(ZON2008-00002)

APPROVAL of a request to rezone subject property from “R1-60” One-Family Low-Density Residential District to Limited “C-1” Neighborhood Retail Commercial District to allow for development of the property for a drive-through restaurant, subject to the property owner agreeing to the following conditions: (ZON2008-00002)

Imperial Properties Inc. (Wendy's Restaurant)- 605 E 15th Street

Project:
 IMPERIAL PROPERTIES
 WENDYS RESTAURANT
 1500-1512 DES MOINES STREET
 DES MOINES, IOWA

CONCEPT SITE PLAN 4 lots 1500, 1504, 1508, & 1512
 A 1/16" = 1'-0"

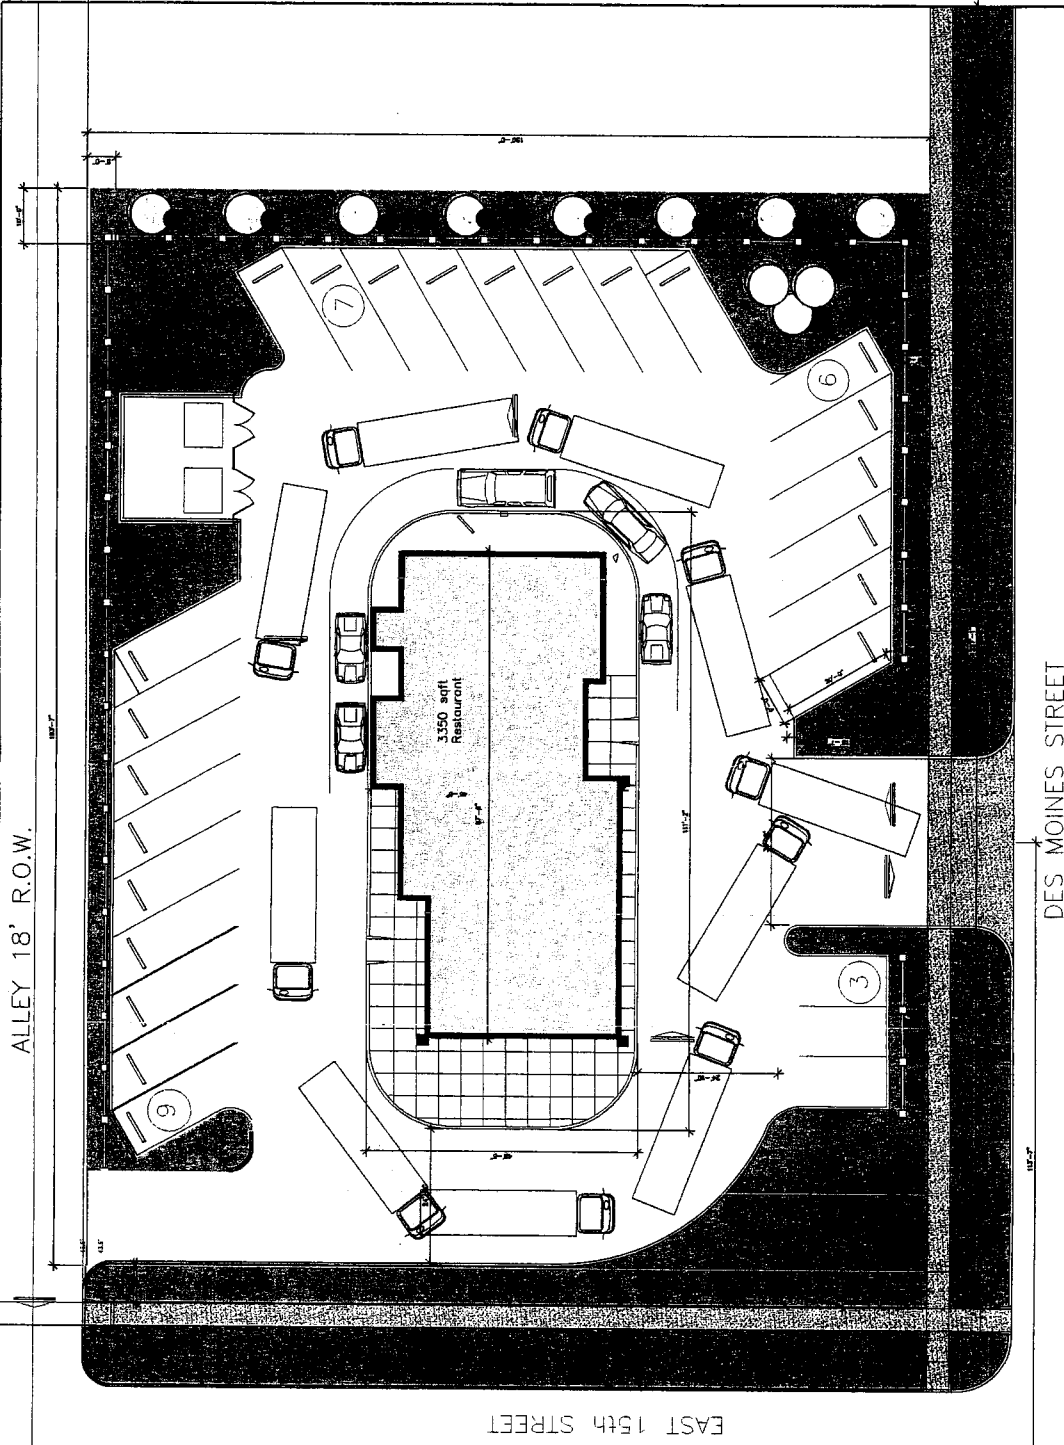
Traffic and Transportation Engineering staff has indicated that any Site Plan for a restaurant will require an entrance from Des Moines Street to be placed a minimum of 20' east of the intersection curve radius with East 15th Street. This will allow for some stacking at the intersection for westbound traffic while allowing eastbound vehicles to enter the subject property without stacking into the intersection. The newly submitted site schematic shows that the driveway is approximately 80 feet from East 15th Street providing for even more stacking distance on Des Moines Street. The most recent submitted schematic also demonstrates that semi tractor trailers can circulate through the site with a single drive access provision.

Bruce Heilman: Asked if there would be a better place for the dumpster further to the west.

Erik Lundy: Noted putting the dumpster too far away from where the refuse comes out of the building could create a problem. Noted currently it is approximately 20-35 feet from the east property line. Noted the Commission has the ability to add the condition.

Tim Urban: Noted much of the angled parking has bumper curbs on them. Asked that they create a straight curb, as the bumper curbs tend to trap trash.

Tim Urban: Asked if the fence was proposed to continue west of the main entry drive and asked why it was necessary.

Vicki Ramirez, 1516 Des Moines Street: Expressed concern that the property line is so close that the fence will block her windows. She likes to look out her window and does not want to look at a fence. Also expressed concern for the access, noting it is too close to her property. Explained there has not been much commercial traffic on Des Moines Street, but was concerned it would increase with a restaurant there.

7. Required trash enclosures shall be constructed of materials compatible with the principal commercial structure and have opaque metal gates.
8. All non-building mounted signs be monument type only;

10. Applicant work with staff on the elimination of the fence on Des Moines Street west of the entry drive and along the north property line, west of the dumpsters.

(A) CONCEPT LOW SCREENING WALL

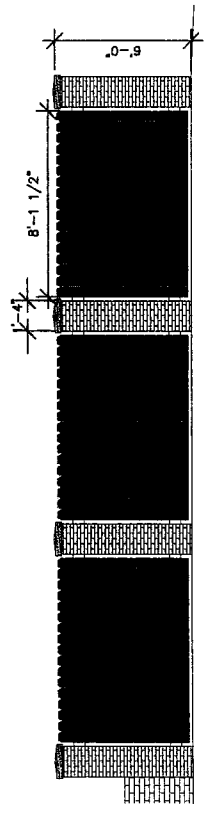
The applicant has submitted a schematic that provided for a six-foot high solid wood fence with stone capped brick masonry pillars between fencing panels. The schematic also provides detail for a three-foot high brick masonry site wall with stone capped brick masonry pillars between wall sections, to be placed along the Des Moines Street landscaped perimeter. The fence is shown abutting the parking lot with landscaping planted toward the adjoining residence. Staff would evaluate this with any submitted Site Plan to determine if the fence is better placed at the property line for reasons of maintenance of the landscaped area and to accommodate snow removal.

David Churchill: Noted the fence drops down to 3' closer to the street. Noted staff had a comment about placing the landscaping on the restaurant side and moving the fence back closer to the property, but he thought his concept would look nicer.

Erik Lundy: Noted the site wall to the south would be required unless a 3' fence or berm was installed because the zoning to the south is R1-60. Also, a six foot wood fence would be required along the north property line. The applicant could go to the Board of Adjustment to request a waiver of those requirements.

4. A six-foot high solid wood fence with masonry pillars shall be used to meet required bufferyard screening from residential property to the east in general compliance with the submitted design schematic.

6. A three-foot high masonry site wall shall be used to meet the parking requirement from Des Moines Street in general compliance with the submitted design schematic.

1500 Block of Des Moines Street CONCEPT SITE PLAN

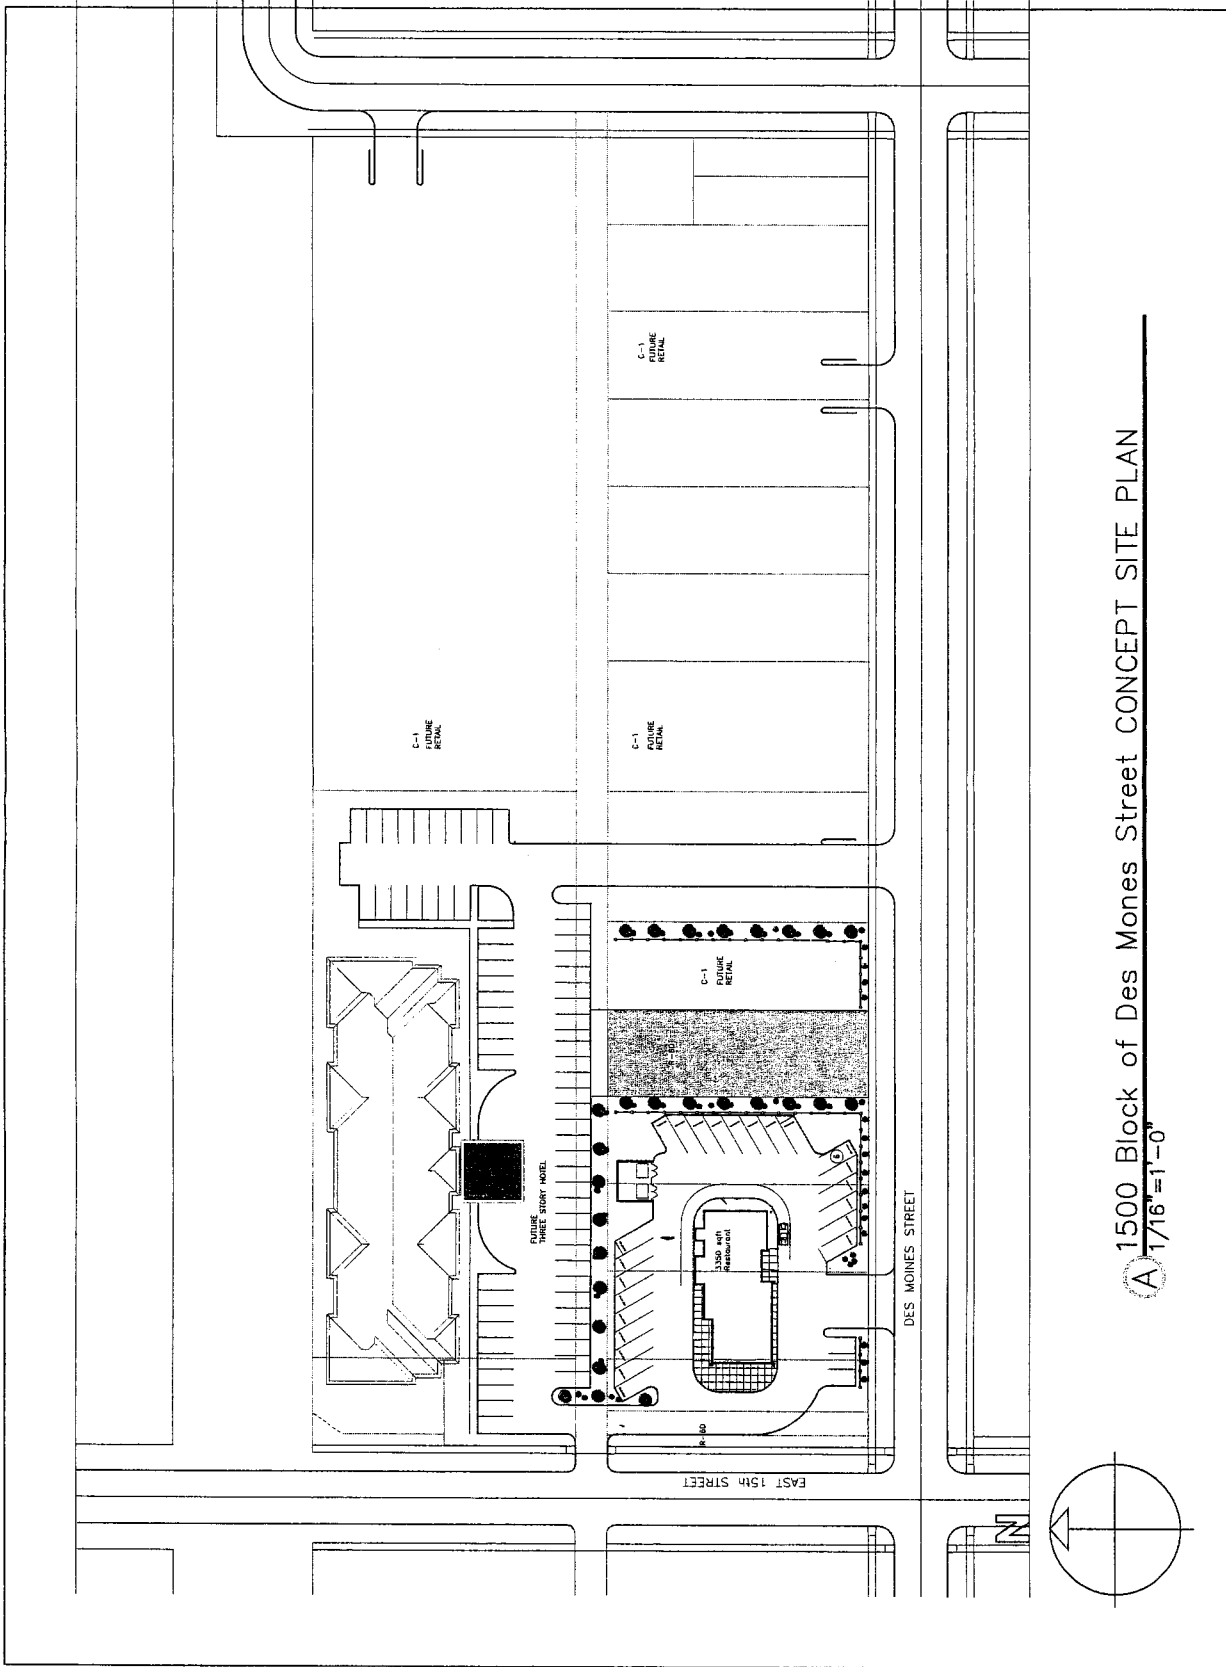
At the request of the Commission, the applicant has submitted a schematic demonstrating how the entire block may be developed for commercial purposes. While staff has not evaluated this schematic extensively, there is concern that there would be a need to perhaps transition to a less intense multiple family residential uses on the eastern portion of the block. This would not affect the subject of the rezoning in either scenario.

Tim Urban: Asked if the applicant had worked with staff on the concept plan for the area. Expressed concern for the access point mid-block and suggested an alternative would be to access through the easterly portion of their parking lot with a vertical access drive.

Mike Ludwig: Noted staff did not review the concept plan for the remainder of the block for code compliance. A problem with asking for the proposed drive to be shifted east would be putting the entrance right next to the existing residence.

1500 Block of Des Moines Street CONCEPT BLOCK PLAN
 A 1/16" = 1'-0"

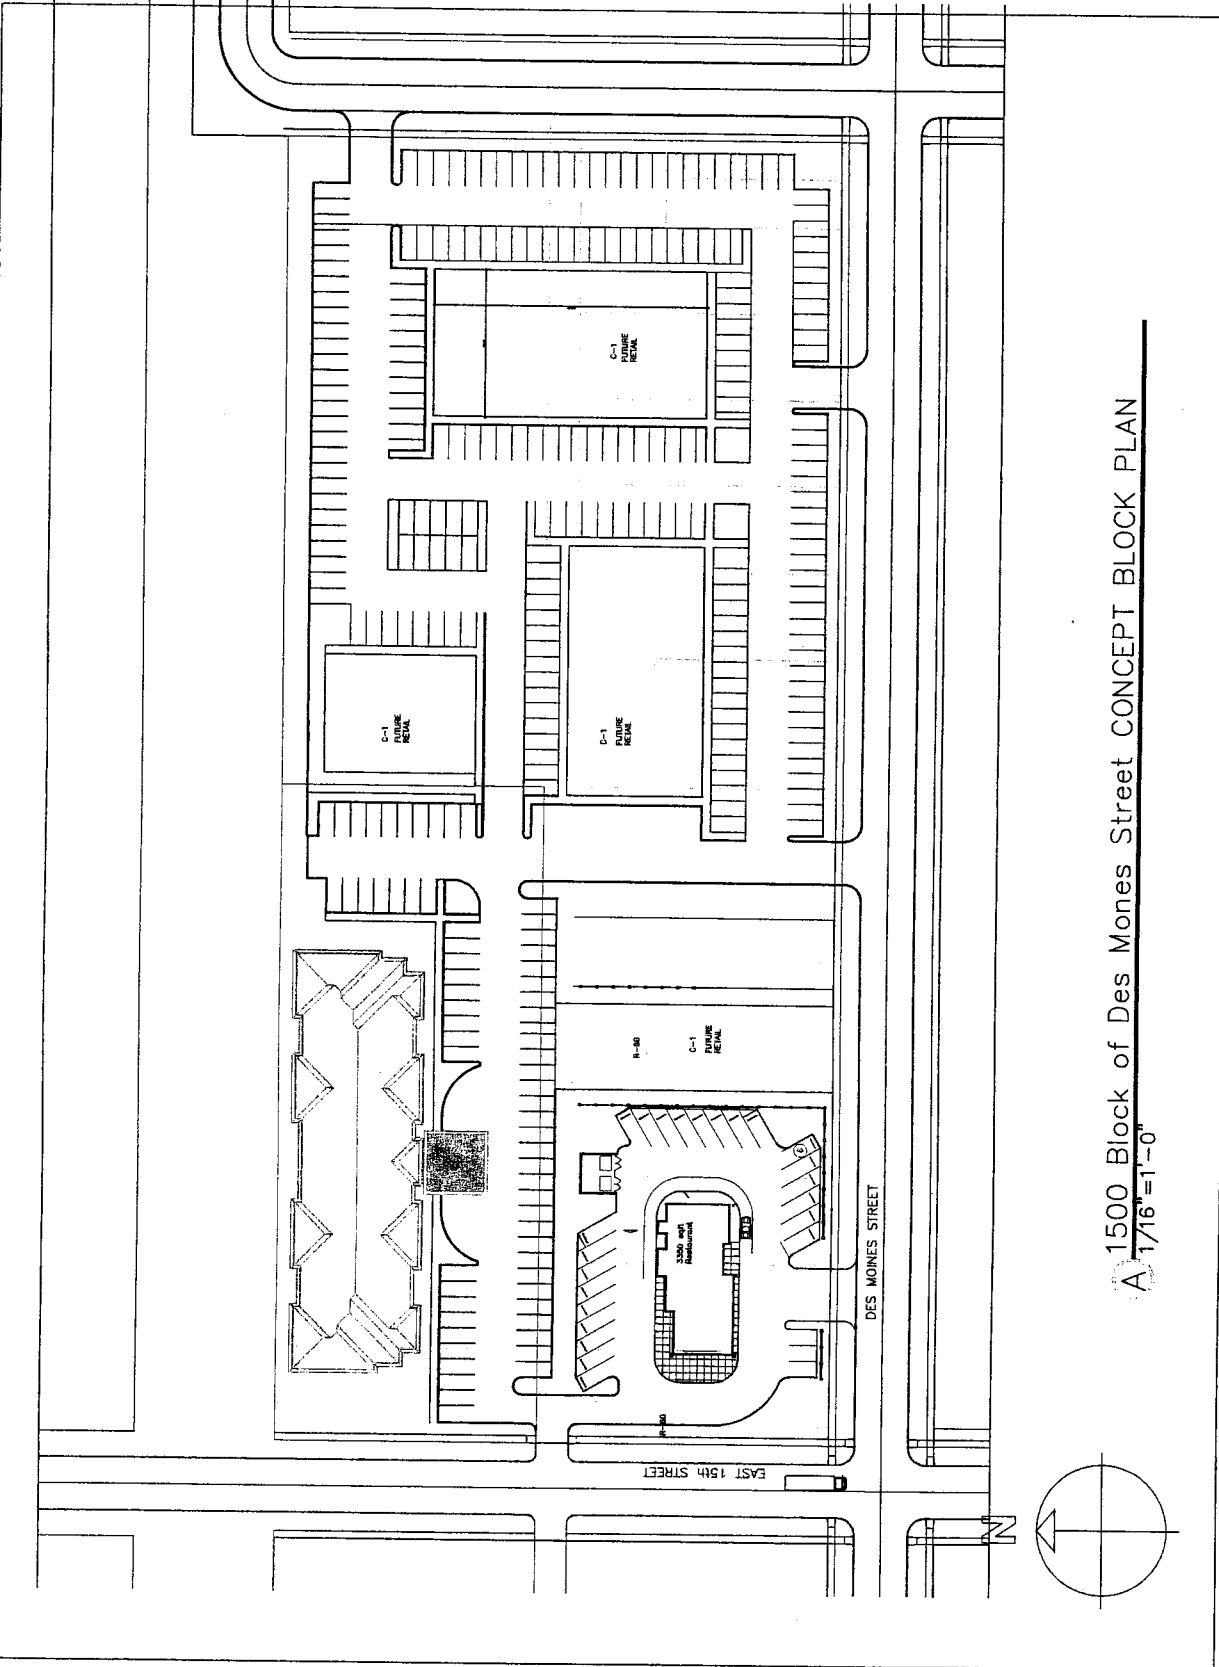
The applicant has also provided a schematic of how the entire East 15th Street commercial frontage and the entire block could develop in the future. Both of these sketches show a drive access from Des Moines Street to serve the IDOT property in the event it is ever disposed of as excess property, as well as a drive connection to East 15th Street in the location of the existing alley entrance. It is conceivable that the alley access could be widened to accommodate a 20' two-way drive aisle in the event the alley would become vacated for private use in the future. This would require approval both by the Iowa DOT and City Traffic Engineering. The drive access from Des Moines Street to the northern portion of the block in the schematic should be shifted further east at least to the mid-point of the block. These projected access points would both require in-depth evaluation at the time of any development proposal on property to the north.

Tim Urban: Asked if, based on the concept plan, for access to serve commercial use fronting on the freeway, the street will have to be converted from a residential to a commercial street and there will have to be a comprehensive plan amendment and zoning changes to make it all a commercial development area.

Mike Ludwig: Noted all issues related to the concept plan for the remainder of the block could be addressed during the zoning stage for that property and the impact on the adjoining properties to the south. Commercial Development on adjoining properties would be subject to Land Use Plan and zoning amendments.
